**Condition:** Helm mounted tachometer inoperative - engine starts and runs normally.

**Cause:** ECM Tach driver circuit at terminal J1-14 inoperative.

**Correction:** Re-wire tachometer to alternate driver at ECM J1-12 with splice to J1-18.

# Figure 1

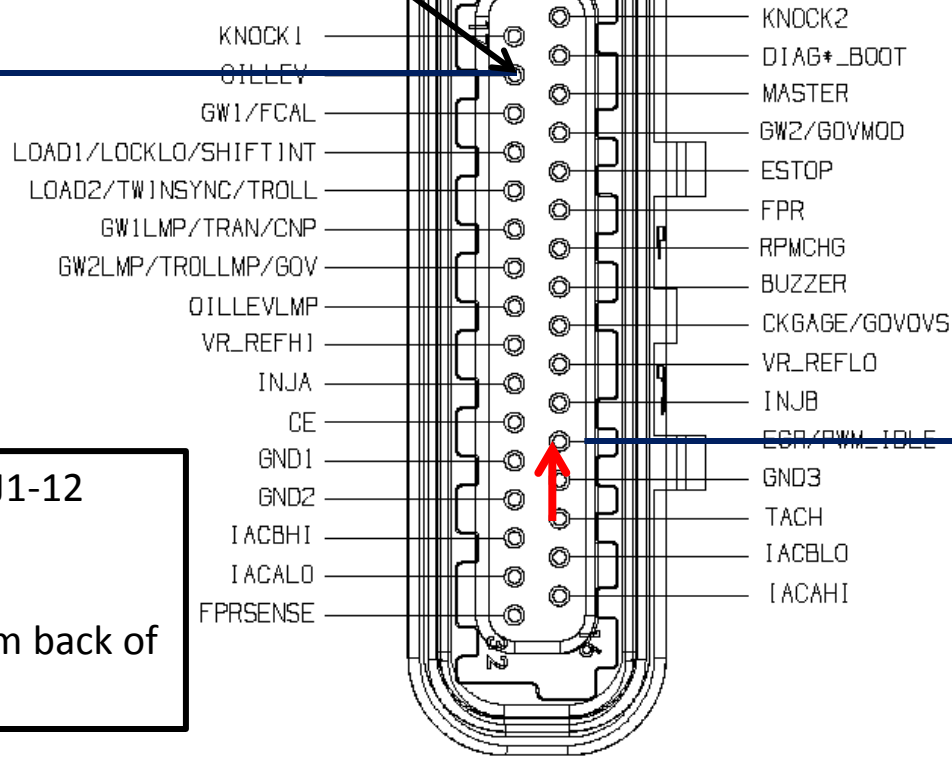
1. Move the tach wire (grey) from J1-14 to J1-12 – Fig 1
2. Add a “pigtail” at J1-18 – Fig 1.
3. Splice “pigtail” to tach wire – Fig 1
4. If a resistor was installed on the back of the tachometer (Fig 2) – remove the resistor

1. Move tach wire from J1-14 to J1-12
2. Add "pigtail" at J1-18
3. Splice "pigtail" to tach wire
4. If present, remove resistor from back of tachometer (see Fig 2)
